**HISTORIC AND DESIGN REVIEW
COMPLIANCE AND TECHNICAL ADVISORY BOARD
July 19, 2024**

HDRC CASE NO: 2024-238
ADDRESS: 4950 SAN PEDRO AVE
LEGAL DESCRIPTION: NCB 9016 BLK 8 LOT 71 DILLEY SUBD
ZONING: O-2, H
CITY COUNCIL DIST.: 2
DISTRICT: Olmos Park Terrace Historic District
APPLICANT: Mariano E Molina | CLEARFIELD CONSTRUCTION LLC
OWNER: Mariano E Molina | CLEARFIELD CONSTRUCTION LLC
TYPE OF WORK: Carport construction, fence replacement, artificial turf installation, and site work modifications
APPLICATION RECEIVED: June 28, 2024
60-DAY REVIEW: August 27, 2024

4950 San Pedro Ave.
San Antonio, TX 78212

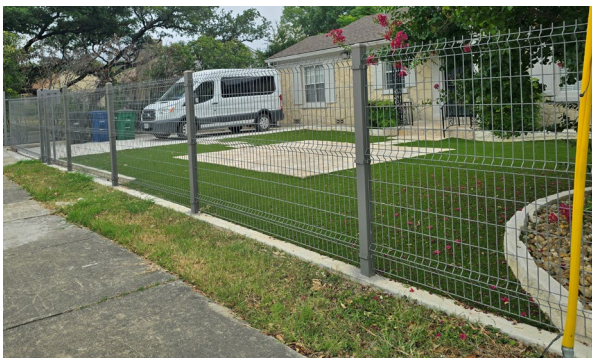
- e. FENCE REPLACEMENT – The applicant is requesting approval to replace the existing decorative metal perimeter fence measuring approximately 4’ in height with a wire mesh panel perimeter fence measuring approximately 6’ in height. Site Elements 2.B.i. states new fences and walls should appear similar to those used historically within the district in terms of their scale, transparency, and character. Design of fence should respond to the design and materials of the house or main structure. Site Elements 2.B.ii. states to avoid installing a fence or wall in a location where one did not historically exist, particularly within the front yard. The appropriateness of a front yard fence or wall is dependent on conditions within a specific historic district. Site Elements 2.B.iii. states to limit the height of new fences and walls within the front yard to a maximum of four feet. The appropriateness of a front yard fence is dependent on conditions within a specific historic district. New front yard fences should not be introduced within historic districts that have not historically had them. If a taller fence or wall existed historically, additional height may be considered. Site Elements 2.B.iv. states to not use exposed concrete masonry units (CMU), Keystone or similar interlocking retaining wall systems, concrete block, vinyl fencing, or chain link fencing. The proposed fence is a variant of chain link fencing and exceeds the height recommended by Guidelines for front yard fences. Staff finds the fence replacement does not conform to Guidelines.

- g. SITE WORK MODIFICATIONS – The applicant is requesting approval to remove the existing front walkway, install square concrete pavers, and install a flagstone-style concrete pad in the front yard. The applicant has not provided staff the measurements for the flagstone-style concrete pad. The Historic Design Guidelines for Site Elements 5.A.i. states to repair minor cracking, settling, or jamming along sidewalks to prevent uneven surfaces. Retain and repair historic sidewalk and walkway paving materials—often brick or concrete—in place. Site Elements 5.A.ii. states to replace those portions of sidewalks or walkways that are deteriorated beyond repair. Every effort should be made to match existing sidewalk color and material. Site Elements 5.A.iii. states to follow the historic alignment, configuration, and width of sidewalks and walkways. Alter the historic width or alignment only where absolutely necessary to accommodate the preservation of a significant tree. Historically, concrete pads are not located in the front yard within the Olmos Park Terrace Historic District. Staff finds the removal of the existing front walkway, installation of square concrete pavers, and installation of a flagstone-style concrete pad in the front yard does not conform to Guidelines.

- i. That the applicant install a decorative metal fence at the front yard measuring no more than 4’ in height.
- ii. That the applicant install a decorative metal fence at the side yard, behind the front façade of the structure, measuring no more than 6’ in height.

Item 4: Staff does not recommend approval of item 4, based on findings a and g. Staff recommends the applicant return the site work to its historic condition.
